Springvale Water Treatment Project

Response to Submissions

February 2017

Figure 1-1

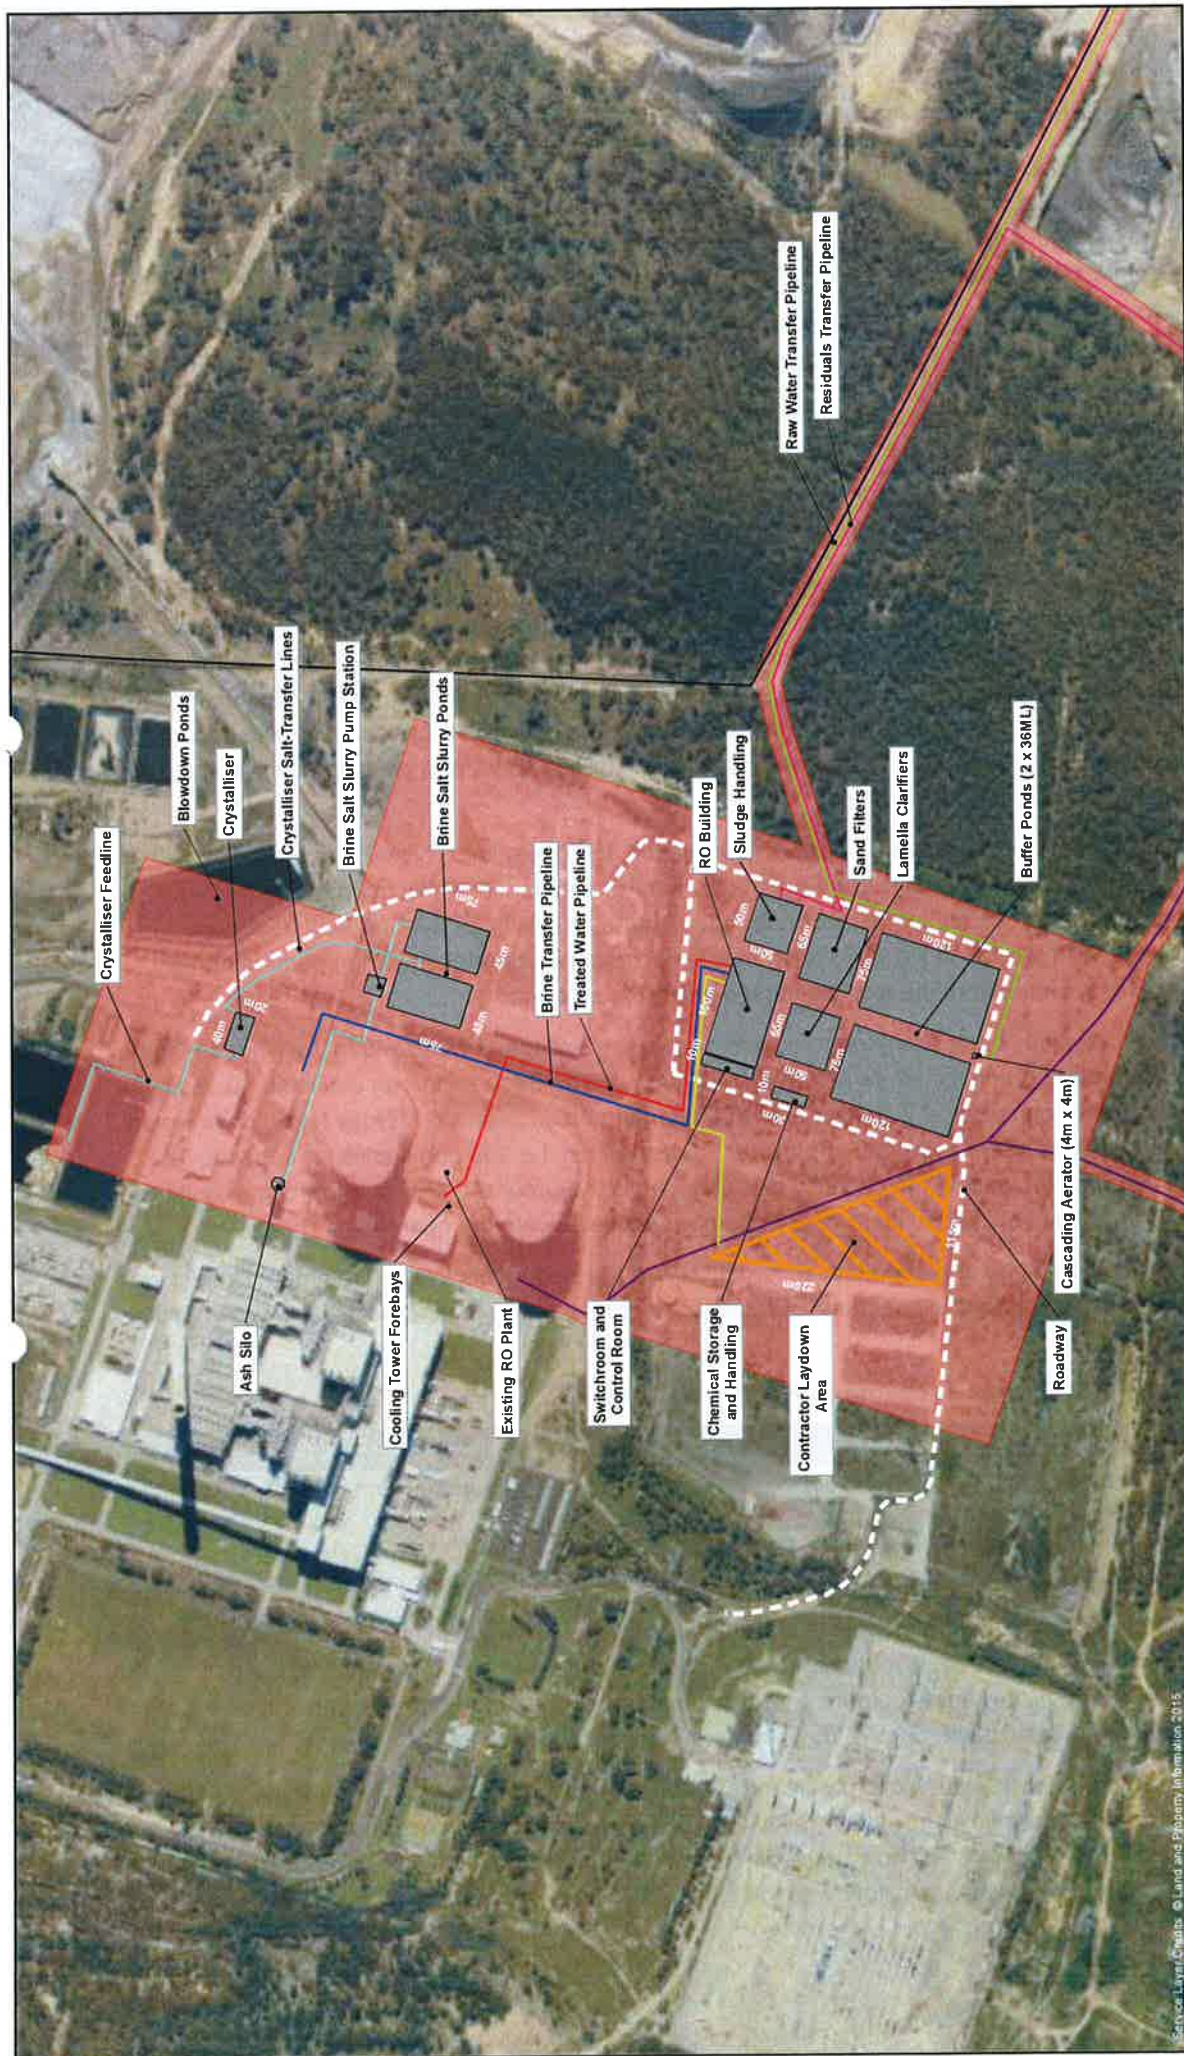
Mining leases are shown in Figure 2.3 of the EIS. A total of 4 leases are identified: MPL314, ML1448, ML1352 and ML1323. However, CCL733 which includes surface areas is also within the project boundary and is not identified in this section of the EIS as being relevant to the project. The Division notes that a section of the Treated Water Transfer pipeline passes across a surface area of CCL733. This appears to be an oversight by the proponent in preparing the EIS.

The revised Project Application Area and the indicative water treatment plant site layout is shown on Figure 1-1 and Figure 1-2 with a summary of amended Project components is included in Table 1-1.

It is confirmed that CCL733 embraces the surface in the vicinity of the originally proposed LDP to Wangcol Creek. The DA has been amended with the addition of a transfer system to TCR and the Project Application Area no longer traverses the mining lease. The amended Project application area is presented in Figure 1-1.

Figure 3-1 2016 daily discharge volumes from LDP006

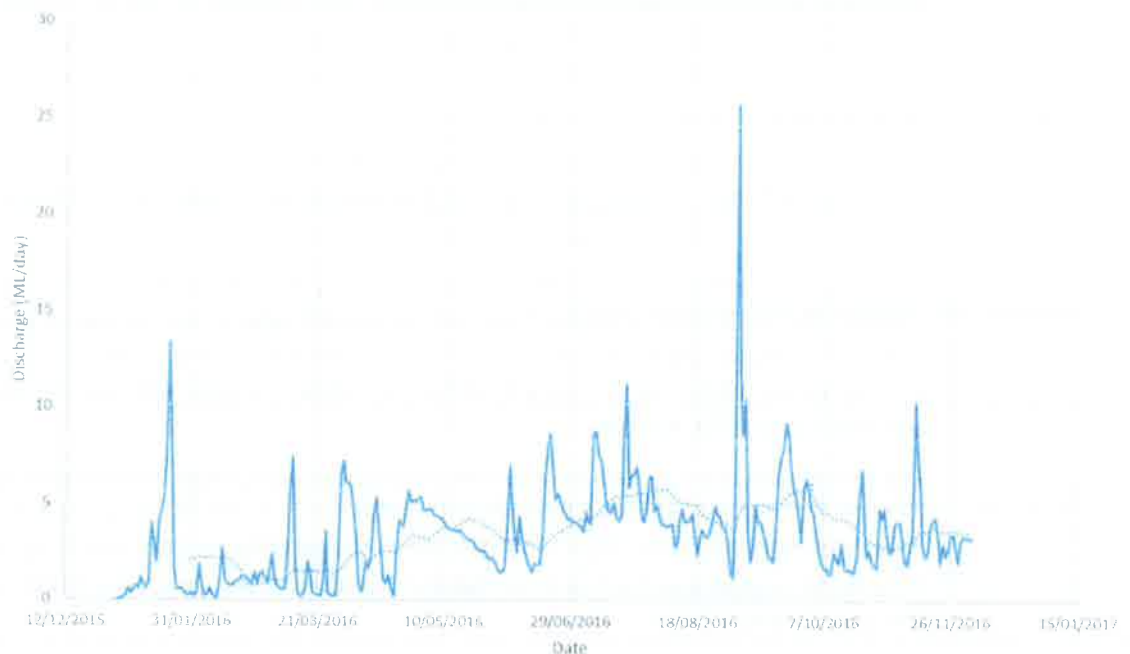
...deterioration in water quality at Wangcol Creek compared to existing conditions through increased discharges at LDP006 as a result of disposal of residue material from the treatment plant at the reject emplacement area REA. This is considered to be a detrimental impact, not a beneficial impact as stated in the EIS.

During 2016 there was a period where SCSS required elevated discharges to remove excess water from their water management system. This excess water volume was leading to elevated groundwater conditions around Cooks Dam and DML Dam. With excess water volume managed down, the average annual discharge has returned to the predicted range. Moving forward the separation of clean water and mine water will improve clarity to what water is actually being contributed to Wangcol Creek by the operations at SCSS and what is contribution from the Lamberts Gully catchment.

It is clear from Figure 3-1 that flow via LDP006 has temporarily risen to approximately 5 ML/day in July, in addition to short term responses to rainfall. Since this time however, groundwater volumes have recovered to approximately 2 ML/day. Discharges from LDP006 are dynamic and it is incorrect to indicate that they average 4-5 ML/day annually. The water and salt balance assessment, provided as part of the Modification 1 to the Western Coal Services Project, further confirms the factors that influence LDP006 discharges and the calibration/validation works undertaken as part of the regional modelling undertaken for the SWTP.

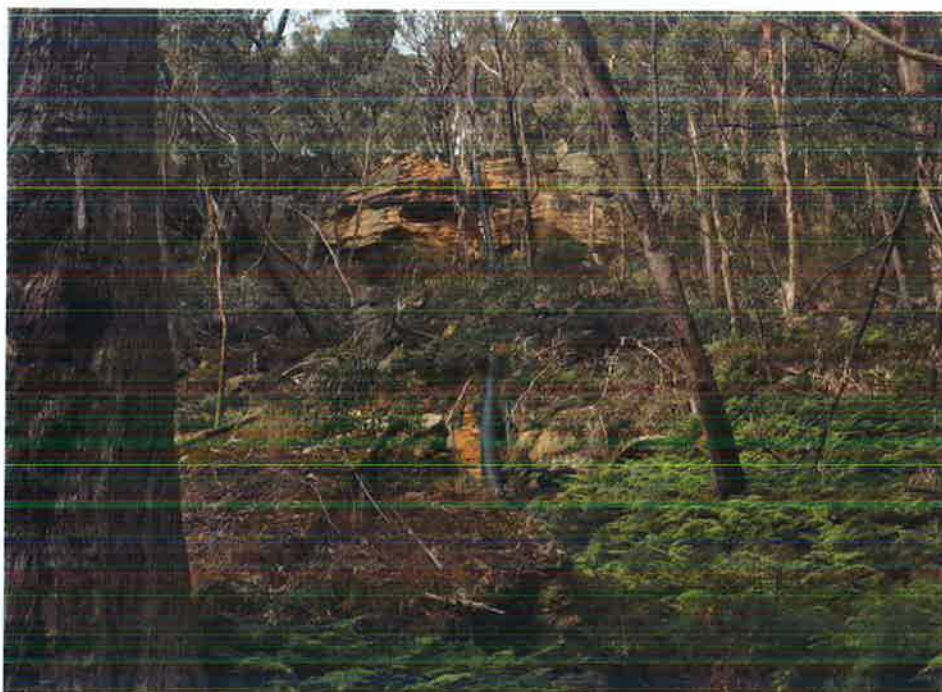
Rock formations A section of the water pipeline passes between a number of rock pagoda formations, including those known as the "Celestory Spurs". The EIS has not considered the potential stability impacts at these formations. Please comment on the potential stability impacts and the measures that would be put in place to limit the risk of these impacts occurring.	Section 3.1.13
	VPA Lithgow City Council has requested a Voluntary Planning Agreement for the project. Please provide details of consultation with Council on this issue.	Section 3.1.14

The Clerestory Spurs are rock formations comprising 12 pagoda studded ridge spurs trending roughly north north-east from the main creek system of Sawyers Swamp towards the Beecroft fire trail. They were named on a Bush Club walk in 2011, as representing a clerestory or the upper part of the nave of a Gothic Church (Bushexplorers, 2016).

The transfer pipeline follows the alignment of a former logging trail which passes through a gully which runs between the spur lines labelled Clerestory Spur 8 and 9. The logging trail has largely regenerated and currently comprises a rough walking track of moderate grade from the ridge of the Newnes Plateau to Sawyers Swamp Creek.

The pipeline is anticipated to be buried in the section and will be installed by either trenching or using directional drilling / trenchless techniques. The pipeline will follow the gully and will have a relative small disturbance footprint ensuring there is no direct impact upon the rock formations on the adjacent spur lines.
